(Peach Bottom Atomic Power Station,
Unit 3)

ORDER FOR MODIFICATION OF LICENSE

SAFETY EVALUATION OF MECHANICAL PLUGS TO BE INSERTED INTO THE BYPASS

HOLES OF PEACH BOTTOM ATOMIC POWER STATION UNIT 3

Figure 1. Plug Installed in Core Plate

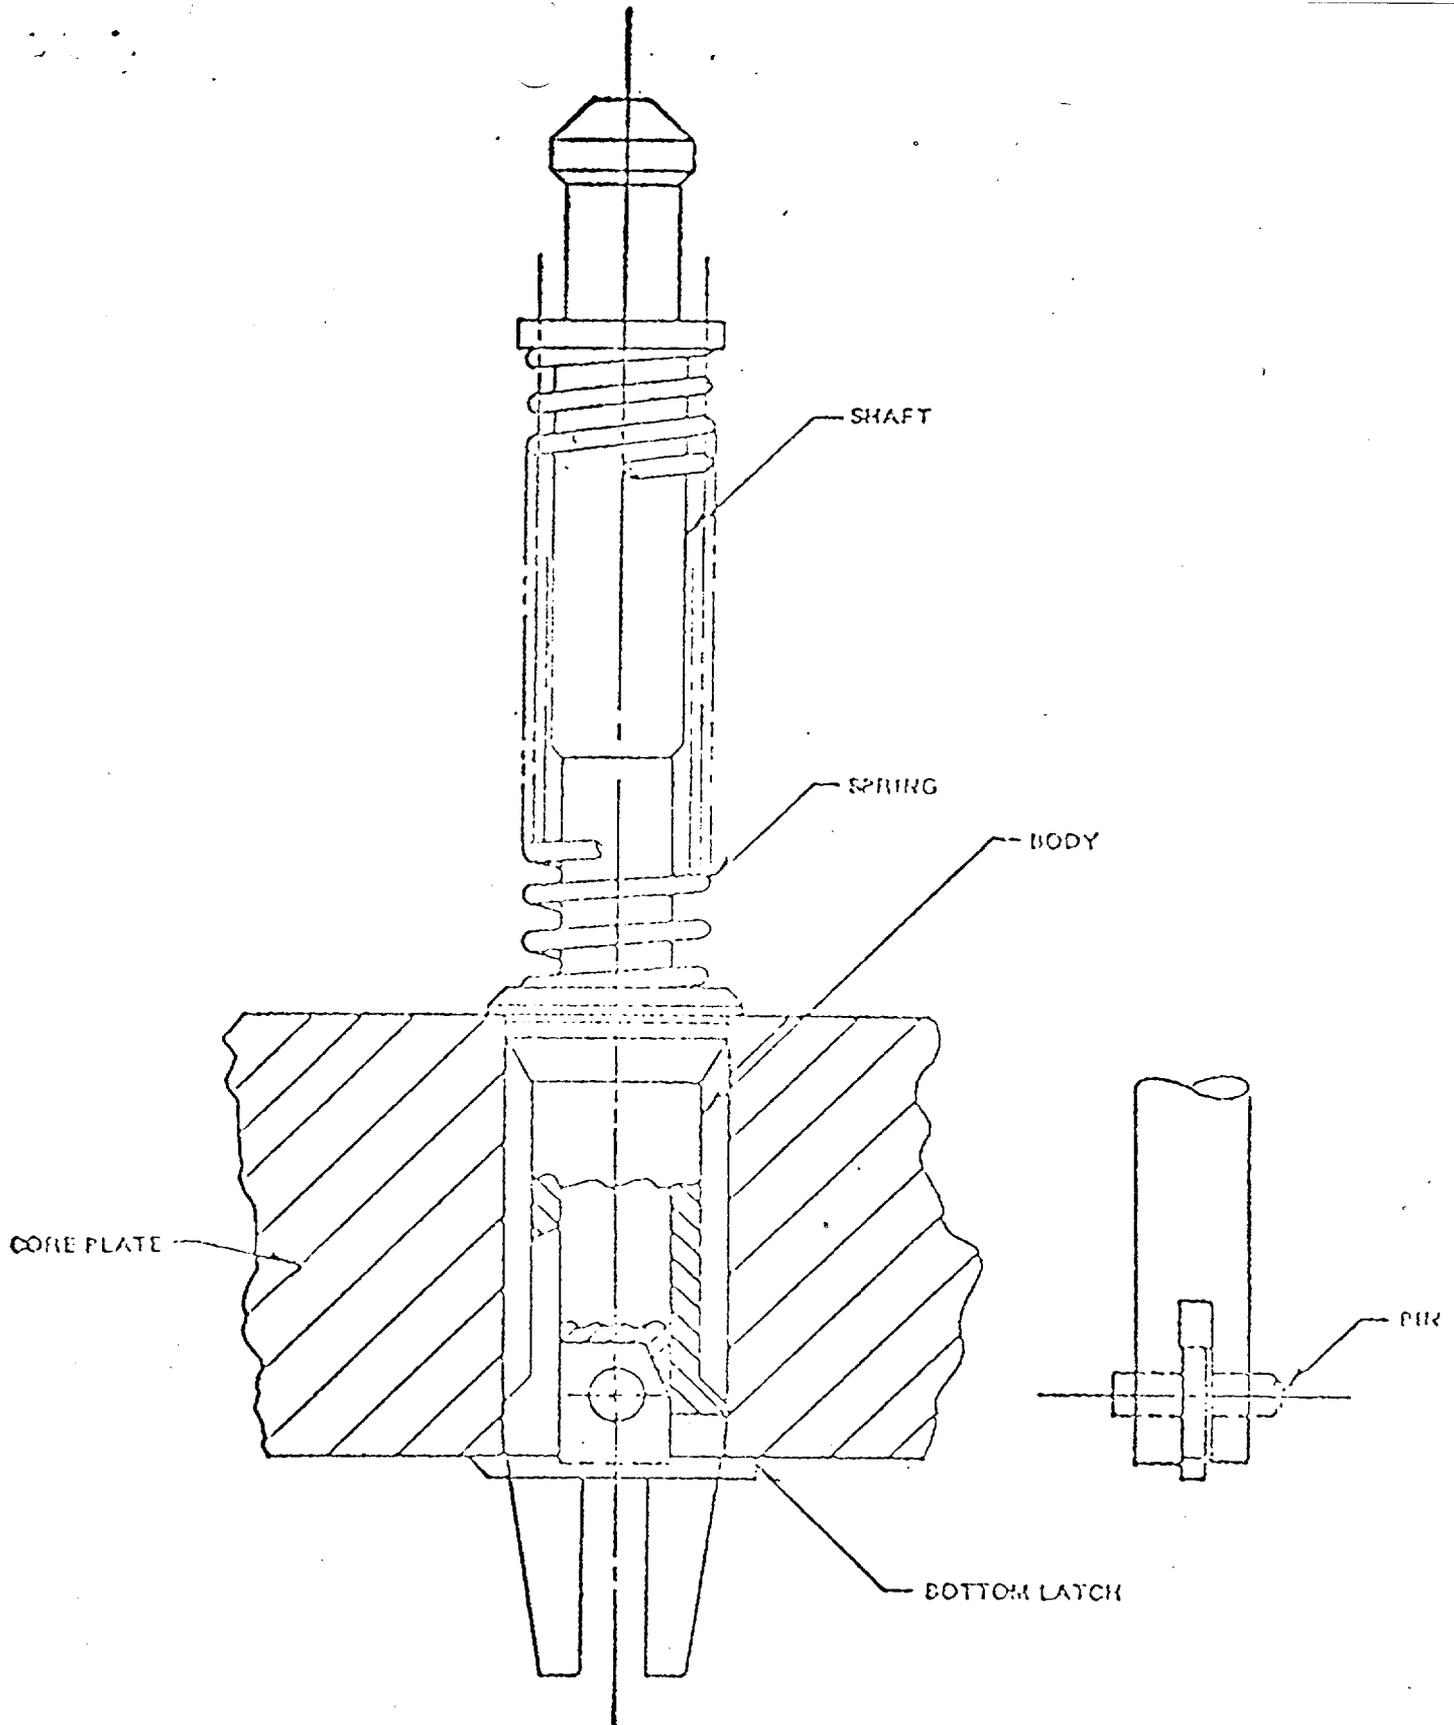
The plug consists of five basic parts, as shown in Figure 1. Identical plugs have previously been installed at Vermont Yankee, Pilgrim, Duane Arnold, Cooper and Peach Bottom Unit 2. The body provides a means of guiding the device into the bypass flow holes as well as a shoulder to support the plug and form a seal against water flow. The shaft extends through the body. A knob is provided at the top of the shaft to provide a means of grabbing the plug during installation and extraction. At the bottom, the latch is attached to the shaft by a pin. The latch is free to rotate during installation. The spring acts against the body and shaft during normal operation to provide the force necessary to offset the pressure differential acting on the body.

During installation, the plug has its latch rotated 90 degrees from its installed position and withdrawn and locked in the body. The shaft is gripped by the installation tool, and the plug is inserted into the bypass flow holes. The body engages the rim of the hole. The shaft is pushed to its full extension, thus lowering and unlocking the latch below the underside of the core plate. The latch then rotates 90 degrees and bears on the bottom of the core plate. After insertion, the plug is pulled with about 30-pound force to test the placement.

The plug can be removed by gripping the top of the shaft with an extracting tool and applying a force of about 500 pounds. The latch's legs will be plastically deformed and the entire plug withdrawn. The plugs previously installed at Vermont Yankee were removed with no abnormalities or loose pieces reported. The force required for removal varied from 500 to 1300 pounds.

Based on a review of the design, the test rig, the installation methods and the previously successful operating experience at Vermont Yankee, Pilgrim, and Duane Arnold, we conclude that the plugs will not fail so as to result in loose parts in the core or result in unplugging of the bypass flow holes. Also, we conclude that the installed plugs will preclude unacceptable channel box damage for at least the proposed fuel cycle. Surveillance programs will be required to confirm the nature and extent of any residual tube excitation and resultant effect, if any, on core components.

Accordingly, we conclude that the installation of the plugs should be authorized. Operation with plugged bypass holes is still under review.

Figure 1. Plug Installed in Core Plate

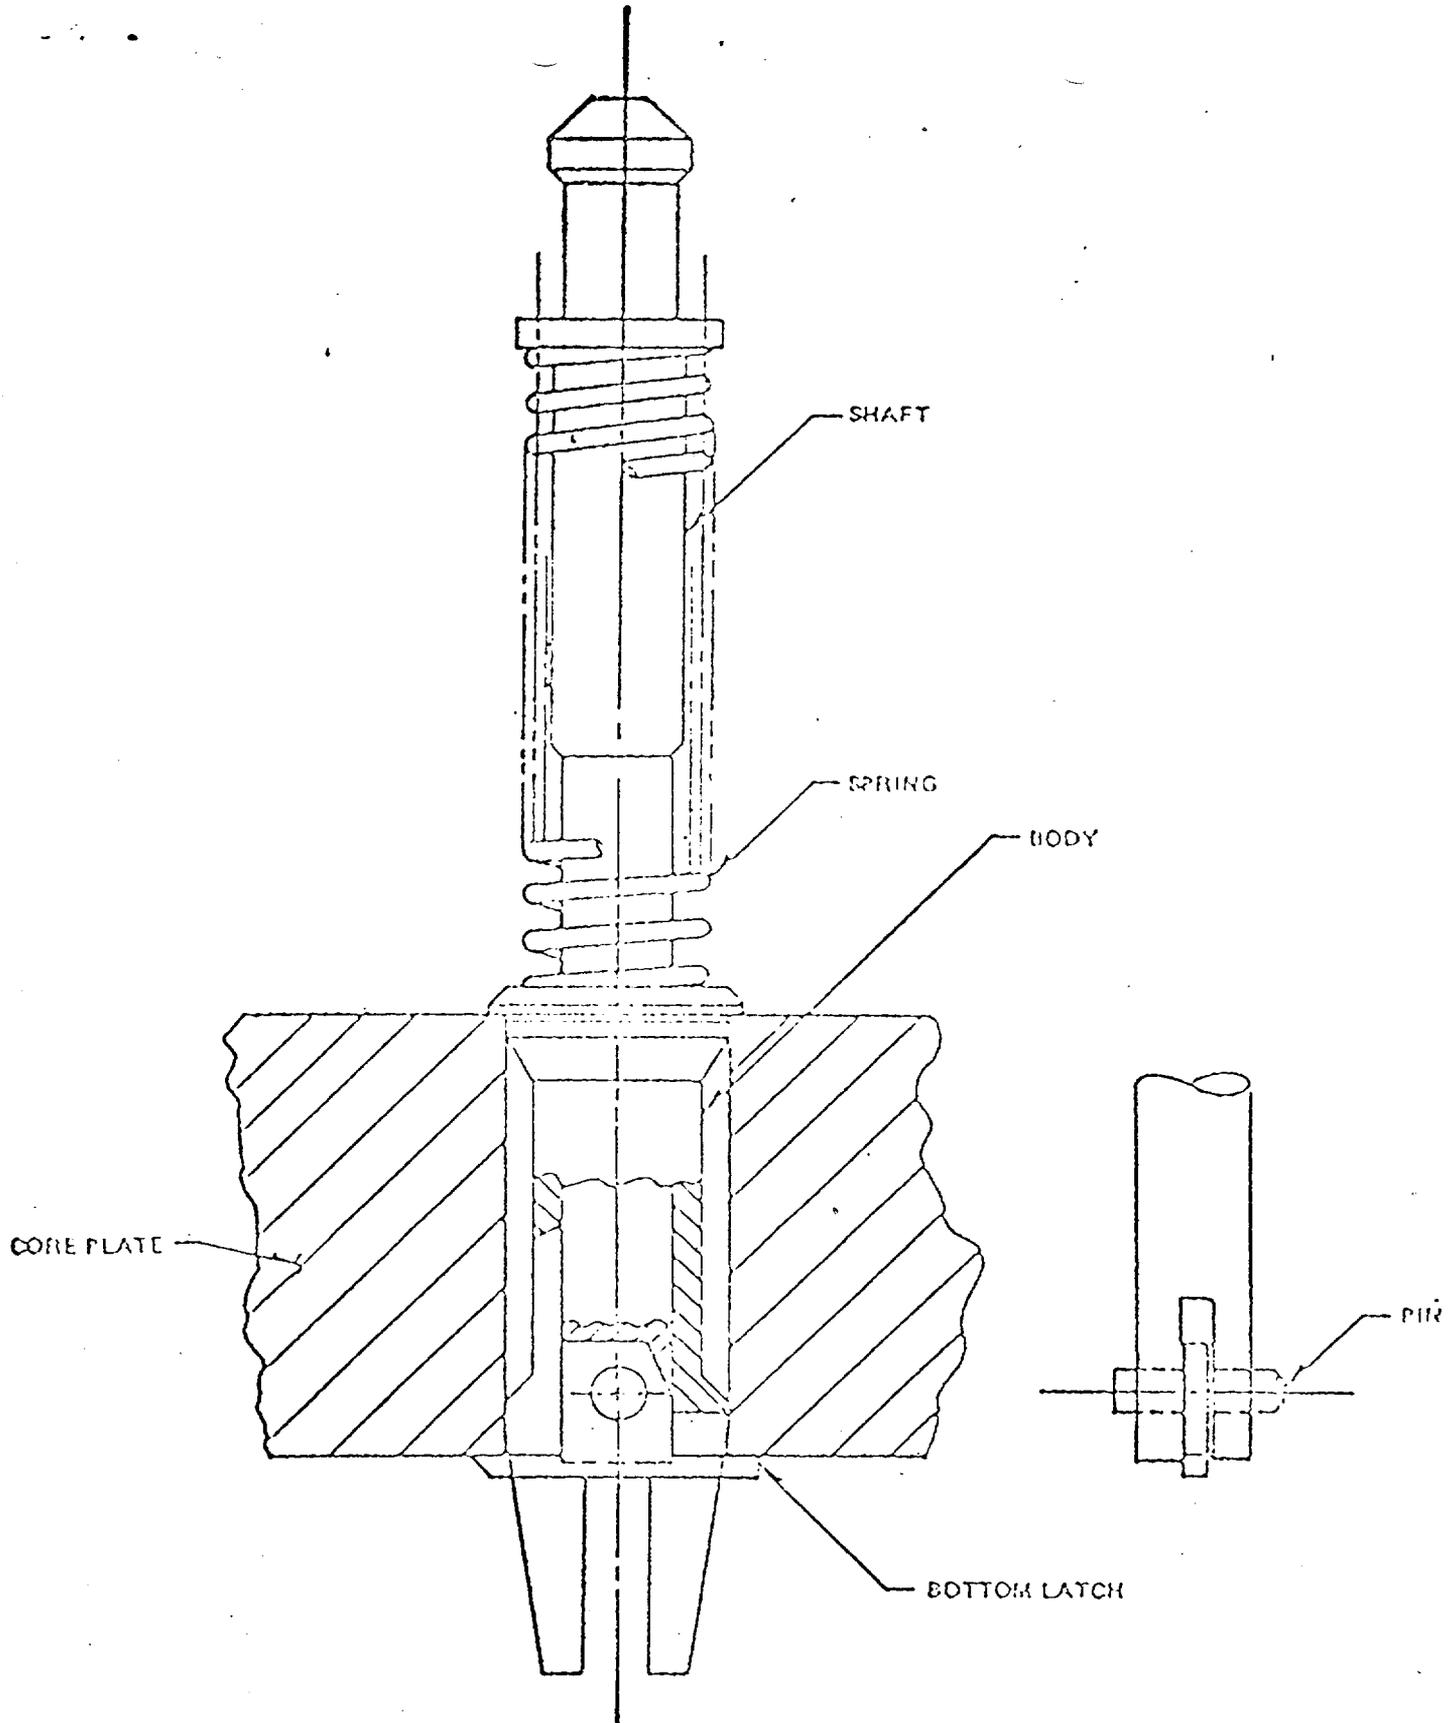
The plug consists of five basic parts, as shown in Figure 1. Identical plugs have previously been installed at Vermont Yankee, Pilgrim, and Duane Arnold. The body provides a means of guiding the device into the bypass flow holes as well as a shoulder to support the plug and form a seal against water flow. The shaft extends through the body. A knob is provided at the top of the shaft to provide a means of grabbing the plug during installation and extraction. At the bottom, the latch is attached to the shaft by a pin. The latch is free to rotate during installation. The spring acts against the body and shaft during normal operation to provide the force necessary to offset the pressure differential acting on the body.

During installation, the plug has its latch rotated 90 degrees from its installed position and withdrawn and locked in the body. The shaft is gripped by the installation tool, and the plug is inserted into the bypass flow holes. The body engages the rim of the hole. The shaft is pushed to its full extension, thus lowering and unlocking the latch below the underside of the core plate. The latch then rotates 90 degrees and bears on the bottom of the core plate. After insertion, the plug is pulled with about 30-pound force to test the placement.

The plug can be removed by gripping the top of the shaft with an extracting tool and applying a force of about 500 pounds. The latch's legs will be plastically deformed and the entire plug withdrawn. The plugs previously installed at Vermont Yankee were removed with no abnormalities or loose pieces reported. The force required for removal varied from 500 to 1300 pounds.

Based on a review of the design, the test rig, the installation methods and the previously successful operating experience at Vermont Yankee, Pilgrim, and Duane Arnold, we conclude that the plugs will not fail so as to result in loose parts in the core or result in unplugging of the bypass flow holes. Also, we conclude that the installed plugs will preclude unacceptable channel box damage for at least the proposed fuel cycle. Surveillance programs will be required to confirm the nature and extent of any residual tube excitation and resultant effect, if any, on core components.

Accordingly, we conclude that the installation of the plugs should be authorized. Operation with plugged bypass holes is still under review.
